Staff Report Department of Public Utilities

Subject: Variance for Blanchard Auto (Detention Pond)

Re: Blanchard Auto
164 Bobby Boss Dr
Loganville, Ga.
Development Review No. 1
K&W Ref. No. 000018

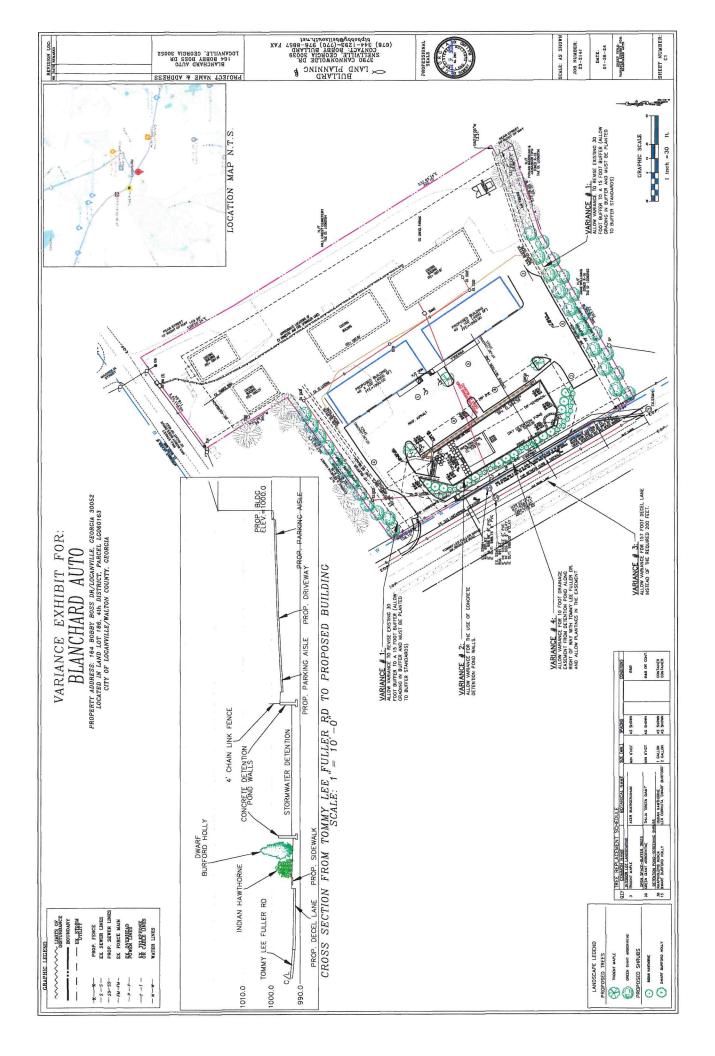
Variance 1: This request involves a reduction in the existing 50 foot buffer to a 15 foot buffer within the setback on the northeastern portion of the property. As the detention pond referenced in Variance 2 requires access, this variance will allow the applicant to remove an existing gravel area and to grade an area to allow access to the western portion of the property from the eastern, and to allow access to the detention pond for maintenance.

Variance 2: The most involved request for a variance concerns the placement of a detention pond on the portion of the property adjacent to Tommy Lee Fuller Drive. For reasons set forth extensively in the attached exhibits, a requirement for a detention facility with a 4 to 1 slope would require too much land in order to accomplish on this particular parcel, and make the applicant unable to place any new commercial buildings on the property. Any alternative requirement for underground detention given the nature of the property and the existing slope would not be economically feasible. Applicants propose a vertical-wall detention facility with

Variance 3: This would reduce the deceleration lane requirement from 200 feet to 157 feet to accommodate the correct road frontage and drainage requirements.

Variance 4: The current zoning and regulations require a 20 foot drainage easement around the detention area. The proposal calls for a reduction of this easement to 10 feet to allow for plantings within 10 feet of the detention area for increased aesthetics issues.

The Department of Utilities recommends that city council deny E&S Rentals, LLC requested variance to change the requirements of a 4:1 pond slope, and to reduce the detention ponds easement to 10°. A reasonable hardship to justify these changes has not been provided. This site does not meet the requirements to modify the pond slopes from a 4:1 with the property size being over an acre as noted on (pg.8) in our Landscape Design Standards and Guidelines for Stormwater Detention Facilities. The 20° easement is a requirement as noted in (section 7.4.5) in our development regulations. Their request to reduce this to 10° also includes trees, and trees are not allowed to be planted within the easement. The required 20° easement will also encroach into the 10° landscape strip. Even with approval of a 10° easement, this will still encroach into the landscape strip and this is prohibited.
